**Economic Commission for Europe****Inland Transport Committee****World Forum for Harmonization of Vehicle Regulations****Working Party on General Safety Provisions****109<sup>th</sup> session**

Geneva, 29 September – 2 October 2015

**Regulation No. 107 (M<sub>2</sub> and M<sub>3</sub> vehicles) –****Proposals for further amendments****Proposal for the 07 series of amendments to Regulation No. 107  
(M<sub>2</sub> and M<sub>3</sub> vehicles)****Submitted by the expert from the International Organization of Motor  
Vehicle Manufacturers\***

Figure 4  
**Framework for the test apparatus**

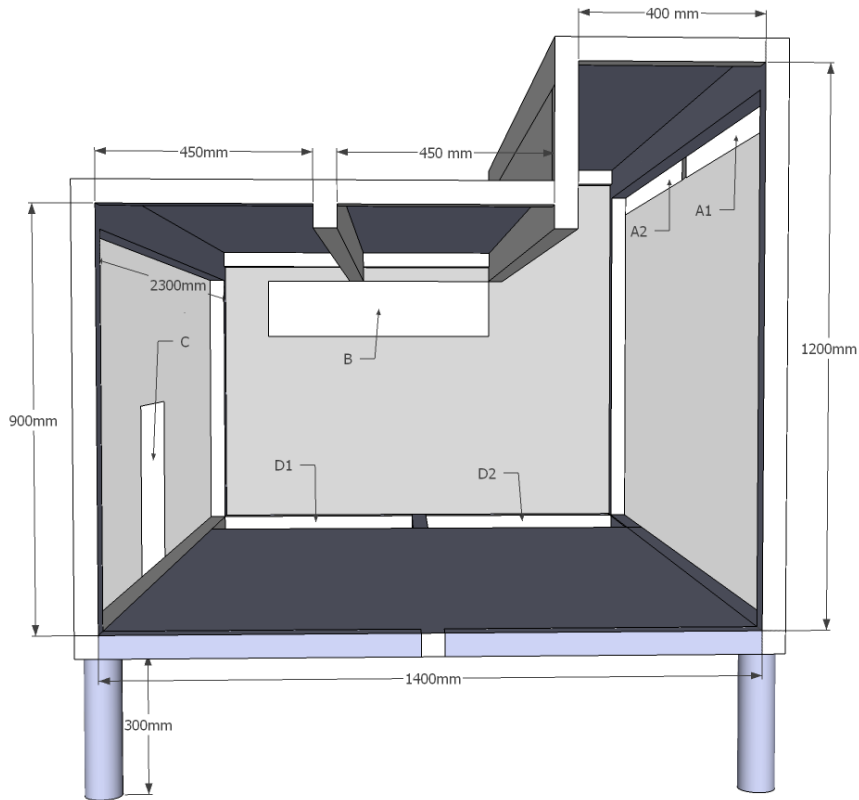
- 1.3.1. The framework of the test apparatus shall be constructed according to Figure 4. The ~~dimensionssizes~~ of the beams are 50 mm × 50 mm and 100 mm × 50 mm respectively. The framework shall be 300 mm above the ground.

1.4.1. In addition to the opening for the fan, the test apparatus includes six apertures. The dimensions and positionings of the apertures are given according to the co-ordinates in Table 3. The positions are referenced given by referring from two diagonally opposite corners (all apertures are rectangular in shape). The apertures are shown in Figure 4.

**Figure 11**

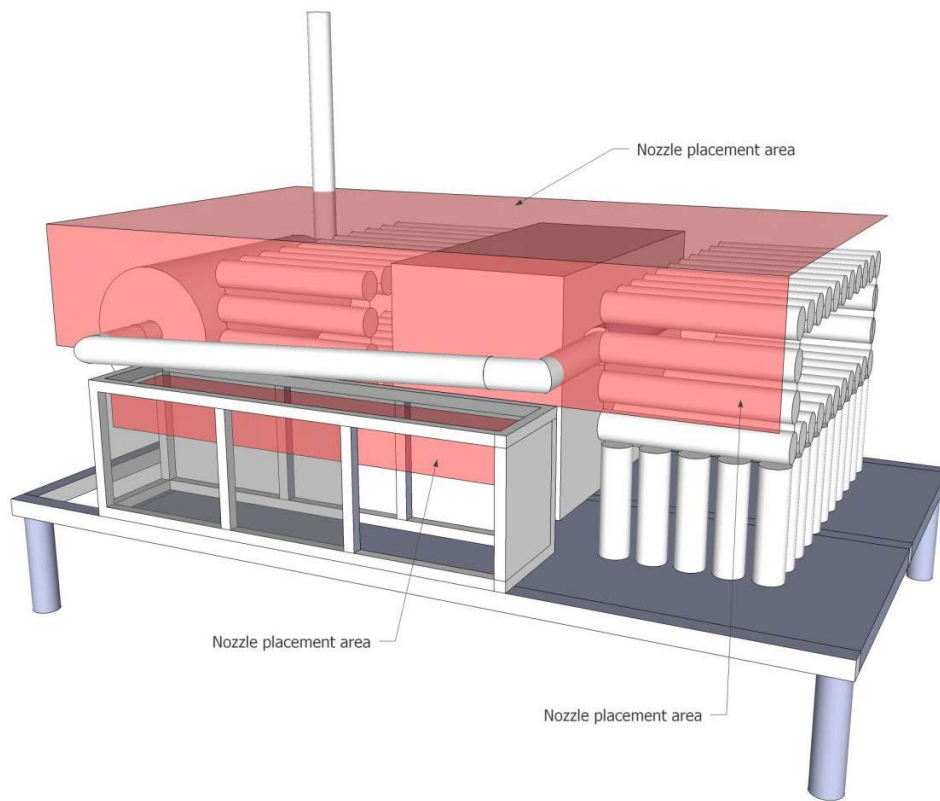
- 3.2. The fire suppression system shall be installed by the system manufacturer or supplier. Figure 11 shows the area where extinguishing agent discharge points such as of nozzles, extinguishing agent generators or extinguishing agent discharge tubes may be located. The discharge points shall be positioned inside the test apparatus, at two different areas:

- (a) In the ceiling and at the rear wall. Discharge points positioned in the ceiling shall be positioned at a minimum of 750 mm above the floor level ( $z \geq 0.75$ ) and outside of Obstruction 1. Nozzles positioned at the rear wall shall be positioned within 350 mm from the rear wall ( $y \geq 1.15$ ) and minimum 450 mm from the floor level ( $z \geq 0.45$ ). Figures 17 and 18 show the area where the nozzles may be located.
